Environmental Planning Commission

Agenda Number: 1
Project #: 2020-004447
SI-2023-01767
Hearing Date: December 21, 2023

Staff Report

Agent	Consensus Planning
Applicant	Sceye Incorporated
Request	Site Plan –EPC
Legal Description	Consensus Planning, Inc., agent for Sceye Incorporated, requests a Site Plan-EPC, for Tract A-1, Plat of Tracts A-1 and A-2, Sunport Municipal addition, containing approximately 2,300 acres
Location	Located on Columbia Dr SE, west of Girard Blvd SE and north of Miles Rd SE.
Size	Approximately 8.2-acres
Zoning	NR-SU

OVERALL EAST ELEVATION

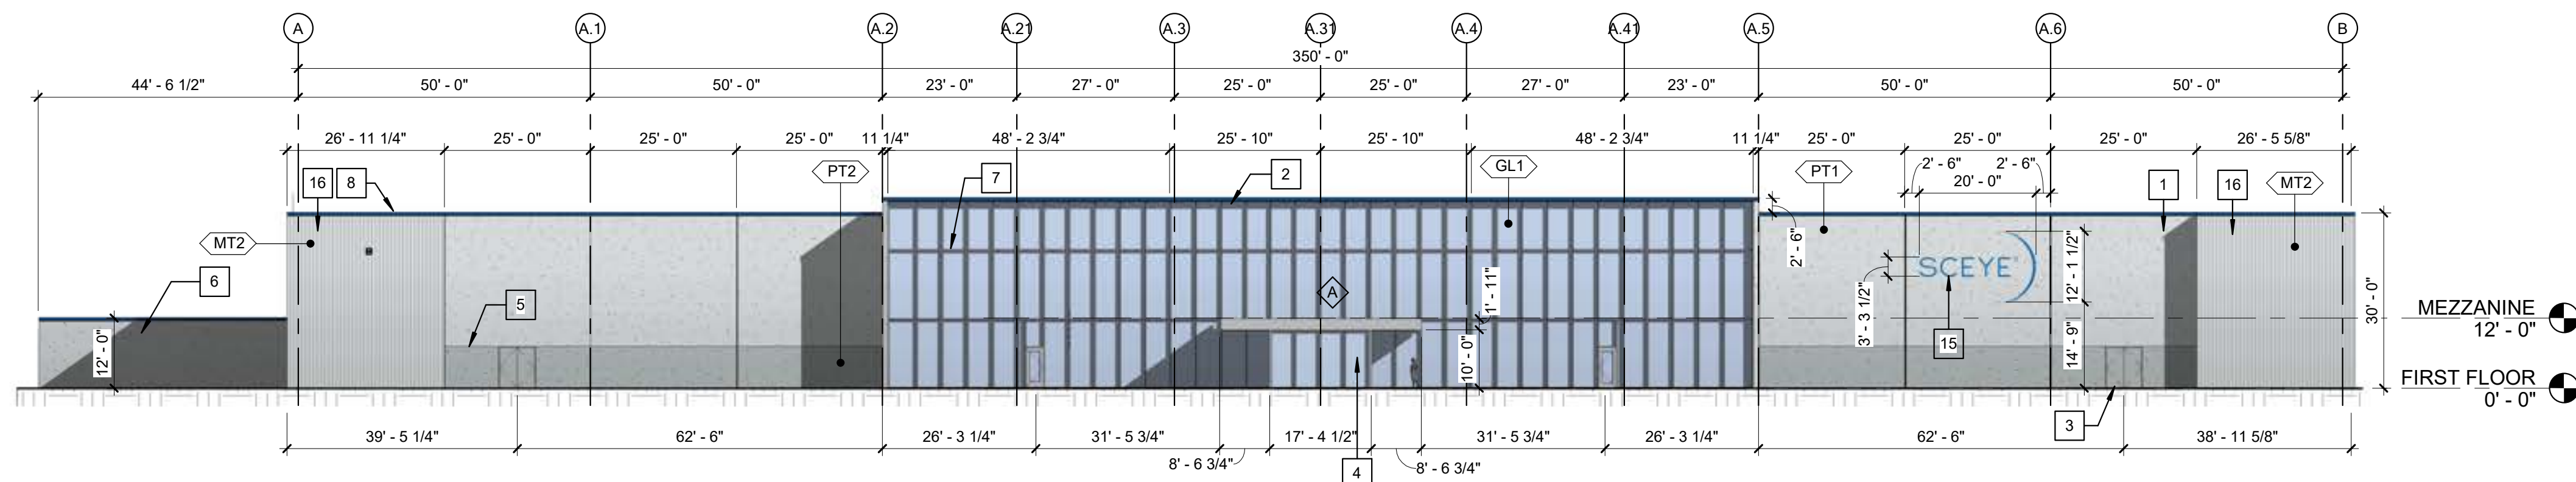
Exterior decorative wall sconces height shall be pursuant to IDO Section 14-16-5-8-(D)(4) and noted on the Exterior Building Elevations – EPC Sheet. Conversely, if the prefinished decorative wall sconces are for security lighting this should be included in Note #7 on the Exterior Building Elevations – EPC Sheet.

The building is a modern industrial style building, characterized tilt-up concrete wall panels in blue and grey colors. The glass vestibule faces the east and is covered with a metal panel canopy. A large part of the exterior on the front elevation of the building is comprised of blue tented glazing. Wall planes both horizontally and vertically to help break up the mass of the building. A strip of blue metal coping wraps around the top perimeter of the exterior of the building to match the color of the signage on the front exterior of the building facing east.

TYPICAL BICYCLE RACK DETAILS

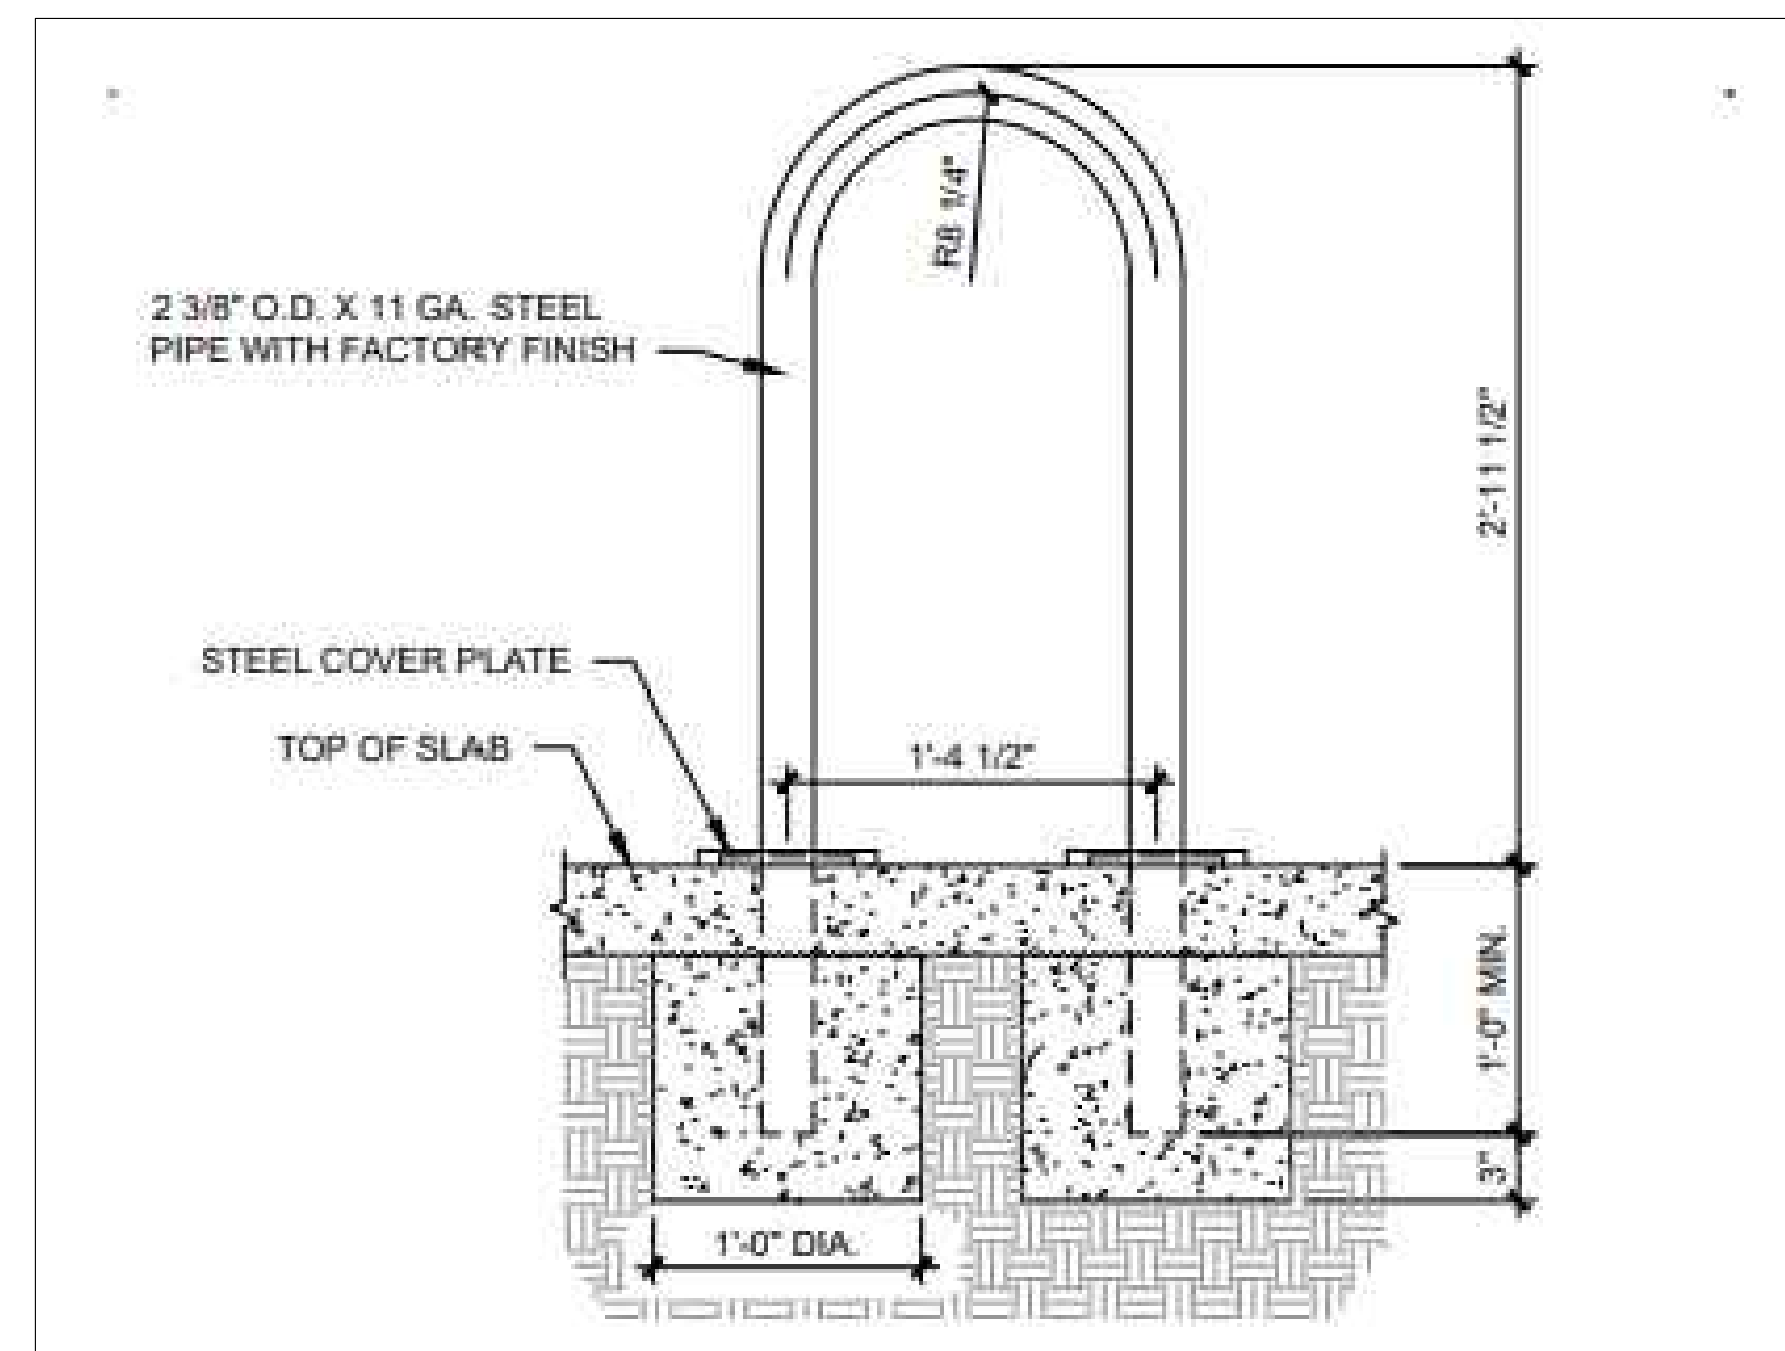
The applicant is proposing to provide 10 bicycle spaces, or 10% of the required regular parking spaces. The bicycle parking is required to be in a visible location pursuant to IDO Section 14-16-5-5(E)(4).
